WILDWOOD

Recommendation Report

Site Plan Subcommittee
of the
Planning and Zoning Commission
January 17, 2017 Executive Meeting
“Planning Tomorrow Today”

Petition Number: P.Z. 15, 16, and 17-14
Petition: Bordeaux Estates at Wildwood – Plat Two
Zoning: R-3 10,000 square foot Residence District, with an Amended Planned Residential Development Overlay District (PRD)

**BORDEAUX ESTATES
AT WILDWOOD PLAT TWO
SITE DEVELOPMENT PLAN
POST CONSTRUCTION BMP DRAINAGE AREA**

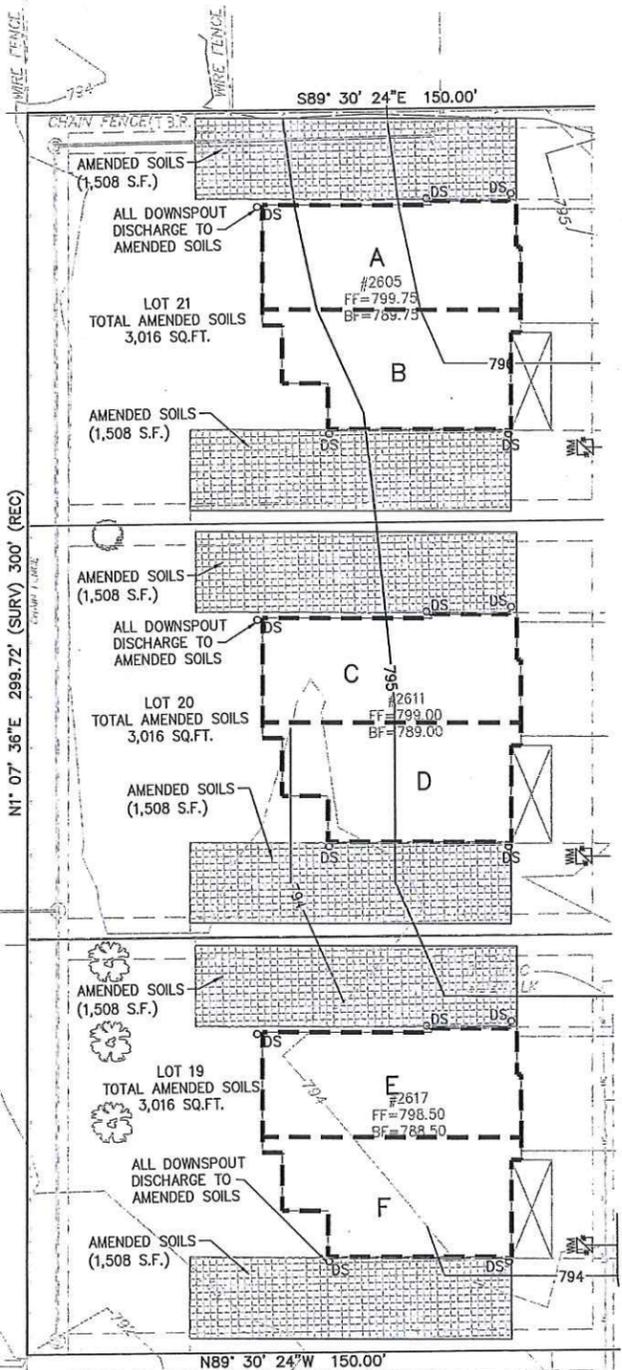
23. Please indicate the four (4) trees on the east side of East Avenue as existing or proposed.
24. Please show the bio-retention plantings as indicated on Sheet 7, including the proposed Bald Cypress Trees, on the Landscape Plan as well.

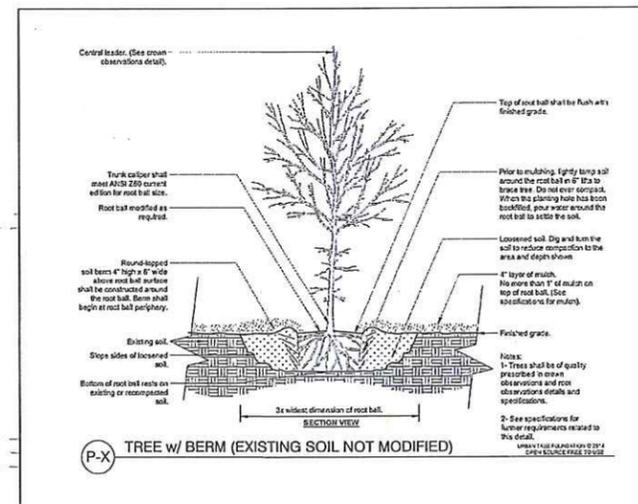
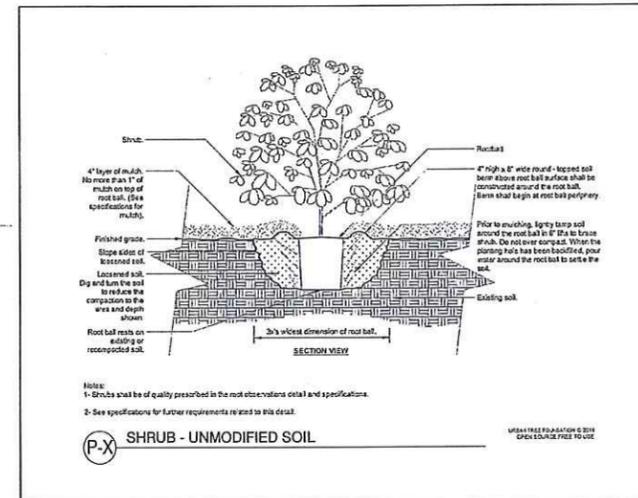
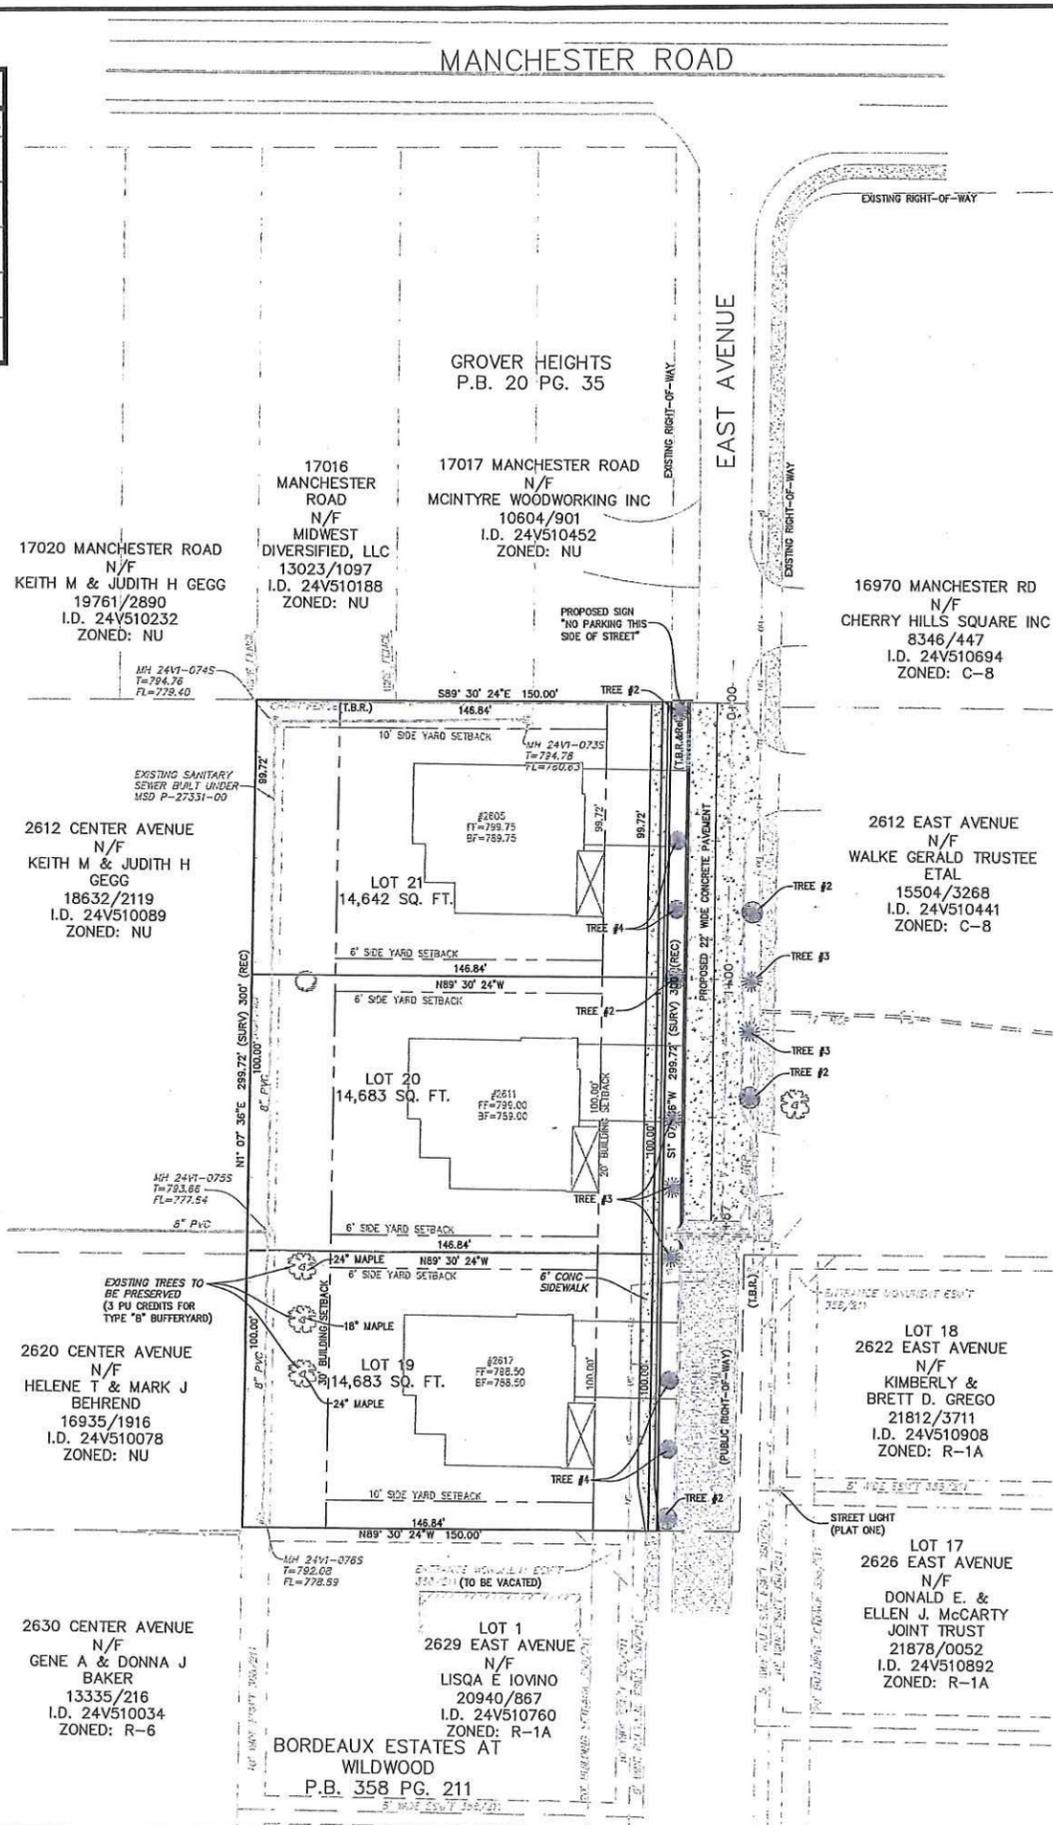
- Street trees to be placed at a spacing of 25 feet on center due to limited space from proposed drive aprons and existing utilities.

19. Amended Soil Disconnection Note #10 on Sheet 6 states that the amended soils shall be maintained by the homeowner of each individual lot.
20. The entrance monument easement has been relocated to Lot 21.
21. Please forward comments upon availability.
22. The tree symbols have been revised as requested.
23. A local note exists on Sheet 10 noting the four (4) trees on the east side of East Avenue as proposed.
24. The bio-retention plantings from the BMP Planting Plan have been added to Sheet 10 as requested.
